RE: North Florida-Southeast Georgia (NFSEG) Regional Groundwater Flow Model

Review Questions and Comments

Appendix A
Initial Review Questions and Comments
Liquid Solutions Group, LLC
May 27, 2016

Appendix B
Preliminary Review Questions, Comments and Responses
Liquid Solutions Group, LLC
October 2015 to January 2016

Orange Lake/Lake Lockloosa

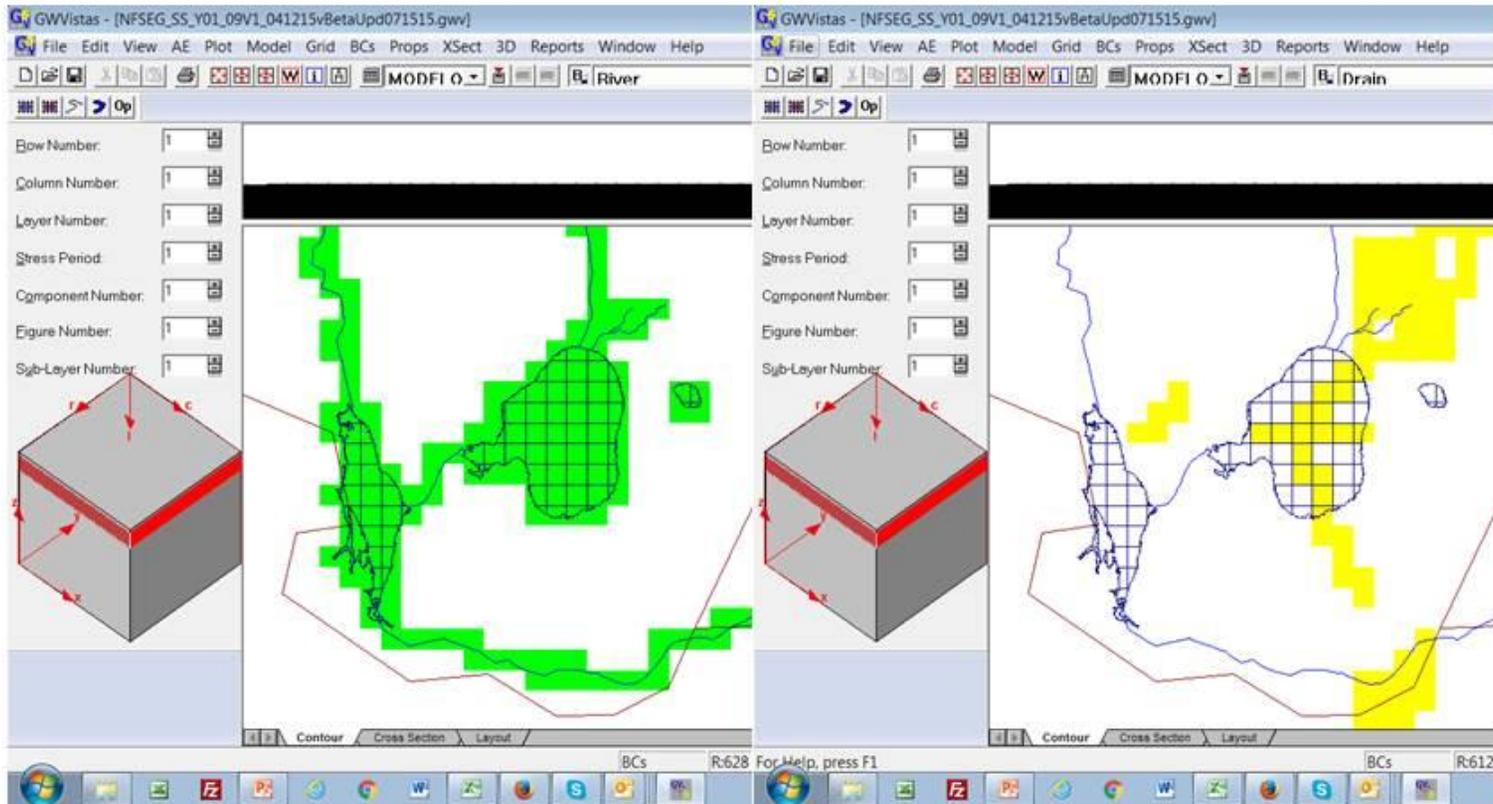
Multiple Drain nodes with area of River nodes representing Lake Lockloosa. The River node assigned heads can be $>$ or $<$ the Drain node assigned heads.

Upper Etonia Creek Chain of Lakes

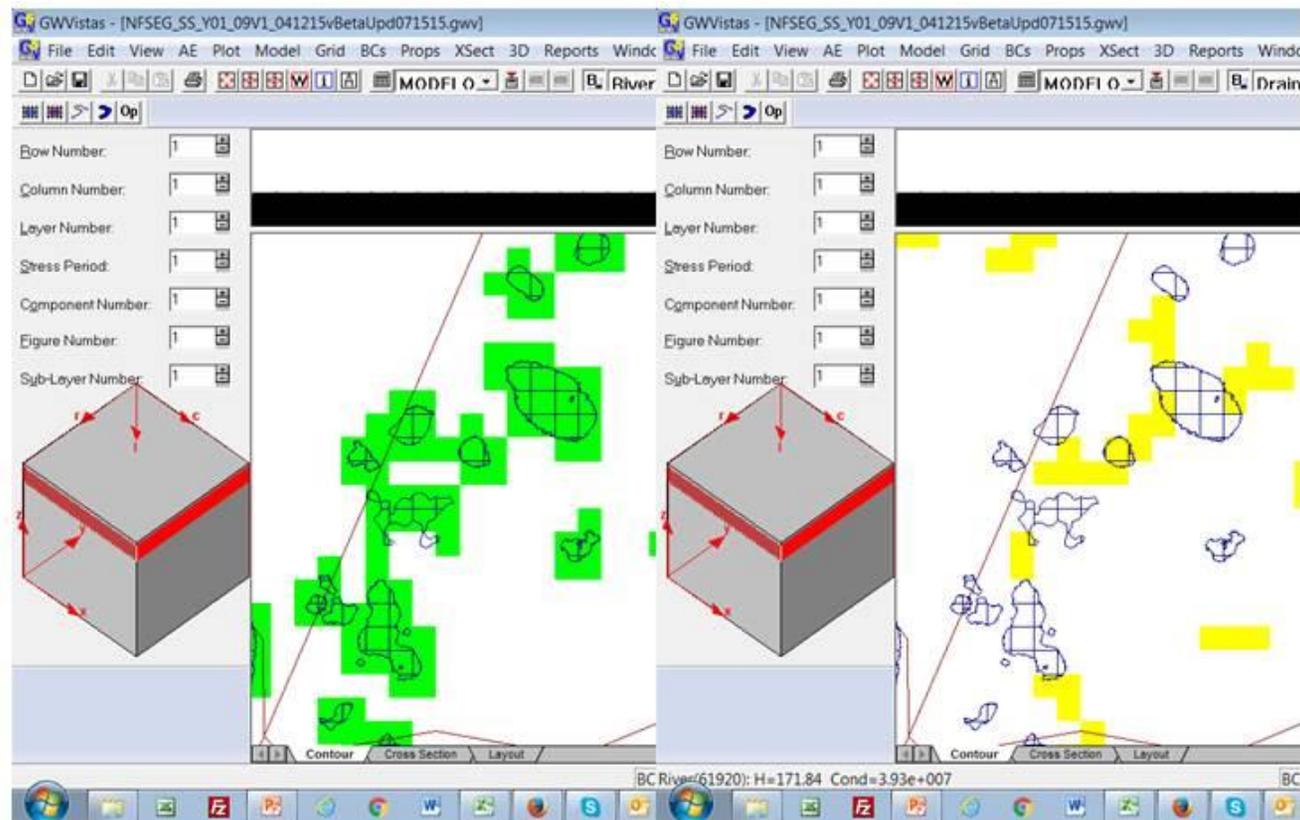
Multiple overlapping River and Drain nodes in Layer 1, particularly across Magnolia Lake.

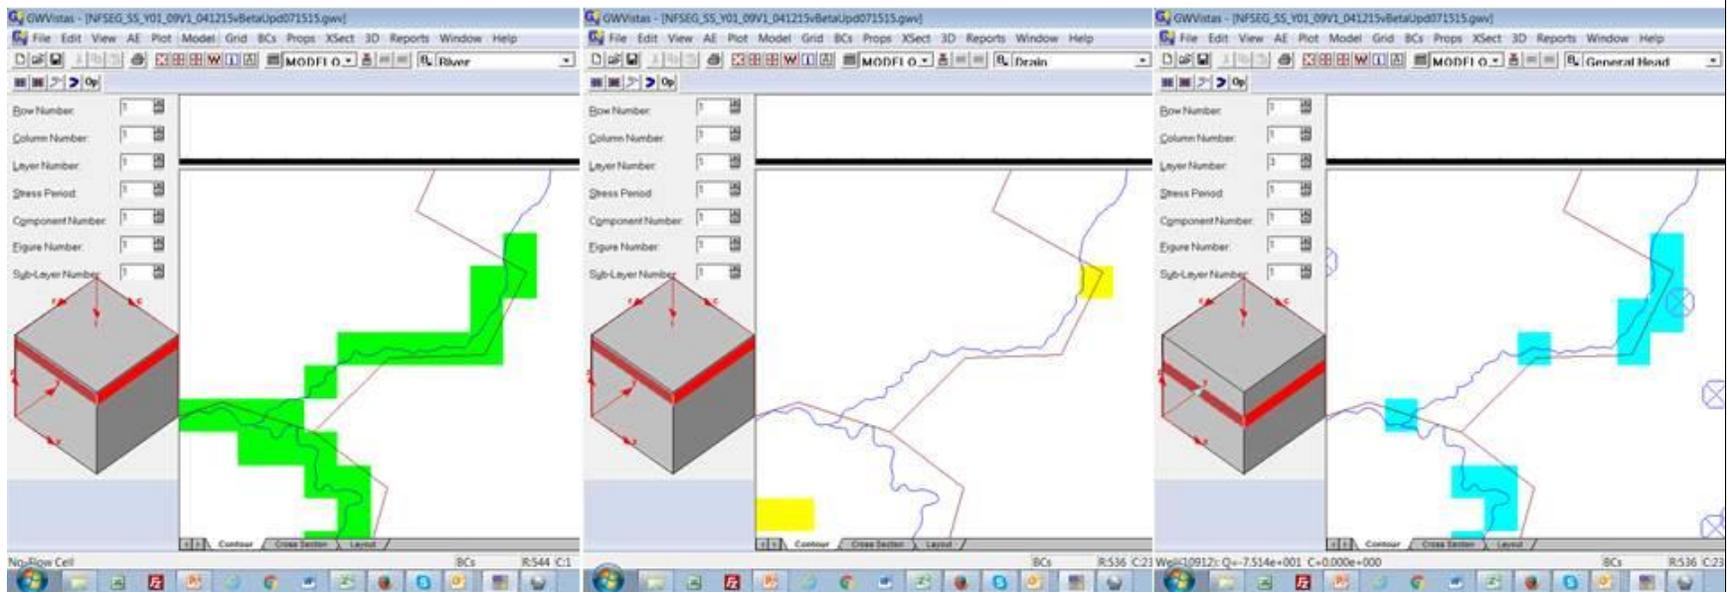
Layer 1 has a River node and Drain node in the same cell (at the location of a spring) with the same head assignment.
